CITY OF CODY  
PLANNING, ZONING AND ADJUSTMENT BOARD  
TUESDAY, FEBRUARY 13, 2018  
CITY HALL COUNCIL CHAMBERS @ 12:00 NOON

<b>MEETING DATE:</b>	FEBRUARY 13, 2018	<b>TYPE OF ACTION NEEDED</b>	
<b>AGENDA ITEM:</b>		P&Z BOARD APPROVAL:	X
<b>SUBJECT:</b>	SITE PLAN REVIEW: WYOMING LEGACY MEATS COLD STORAGE BUILDING SPR 2018-09	RECOMMENDATION TO COUNCIL:	
<b>PREPARED BY:</b>	TODD STOWELL, CITY PLANNER	DISCUSSION ONLY:

<b>MEETING DATE:</b>	FEBRUARY 13, 2018	<b>TYPE OF ACTION NEEDED</b>	
<b>AGENDA ITEM:</b>		P&Z BOARD APPROVAL:	X
<b>SUBJECT:</b>	SITE PLAN REVIEW: LEGEND TOWERS OFFICE EXPANSION (RADIO STATION). SPR 2018-10	RECOMMENDATION TO COUNCIL:	
<b>PREPARED BY:</b>	TODD STOWELL, CITY PLANNER	DISCUSSION ONLY:

<b>MEETING DATE:</b>	FEBRUARY 13, 2018	<b>TYPE OF ACTION NEEDED</b>	
<b>AGENDA ITEM:</b>		P&Z BOARD APPROVAL:	X
<b>SUBJECT:</b>	SITE PLAN REVIEW: SEASONAL GREENHOUSE. SPR 2018-08	RECOMMENDATION TO COUNCIL:	
<b>PREPARED BY:</b>	TODD STOWELL, CITY PLANNER	DISCUSSION ONLY:

Parking lot Boundary

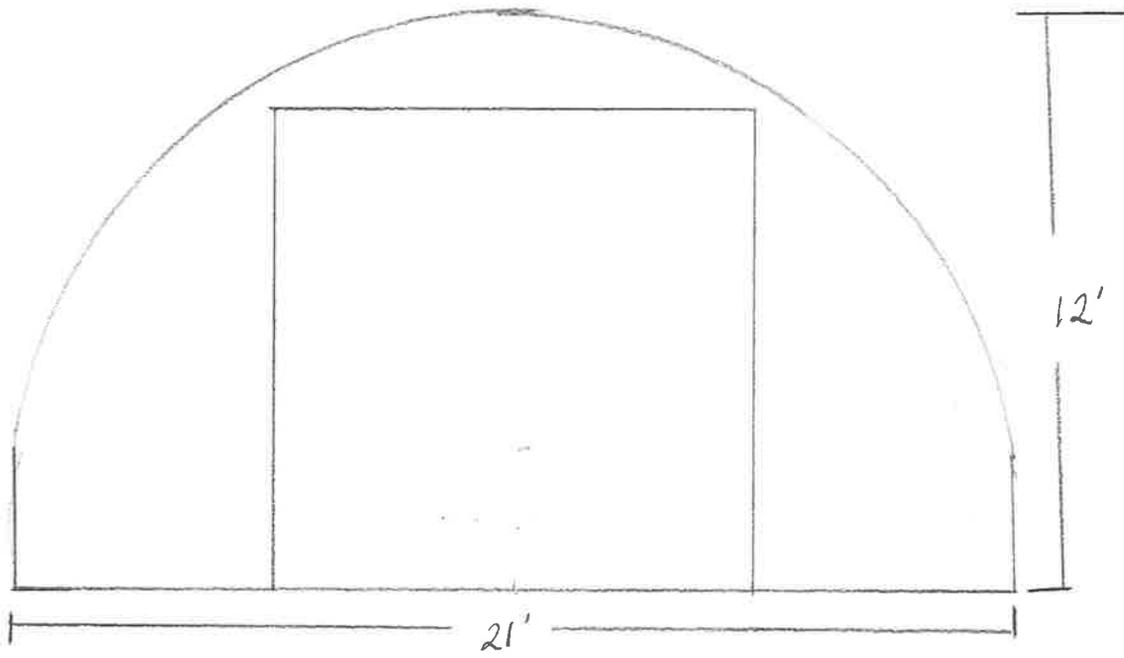
It is recommended that the Planning and Zoning Board grant the variance to the buffer requirement and approve the project, subject to the following items:

1. Use of the portable toilet requires permission from City Council.
2. A variance to the fire hydrant requirement is needed from City Council.
3. Approval is limited to the time requested (May through July, 2018).
4. Work with staff on the layout of the ADA parking space, unloading area. Staff is authorized to approve modifications to the parking plan that are in compliance with the parking ordinance.
5. The project must otherwise comply with the site plan and applicable building, fire, and electrical codes.

Front view

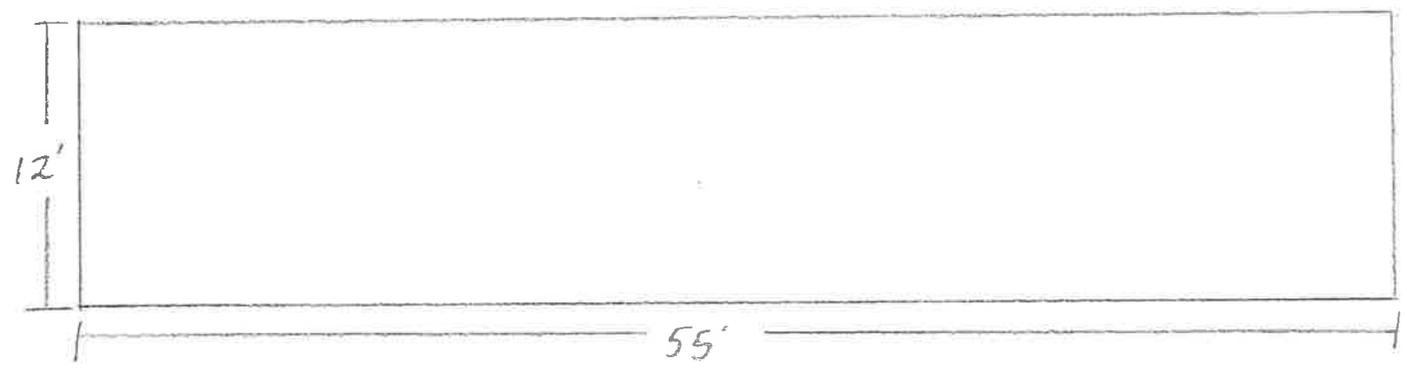
A drawing of the proposed sign is attached. As the sign will be in place less than 120 days, it is classified as a temporary sign under the City sign code. Temporary signs can be of vinyl, as is proposed, and up to 32 square feet. It will be mounted on an entrance gate/fence on the property near the connection to Yellowstone Avenue.
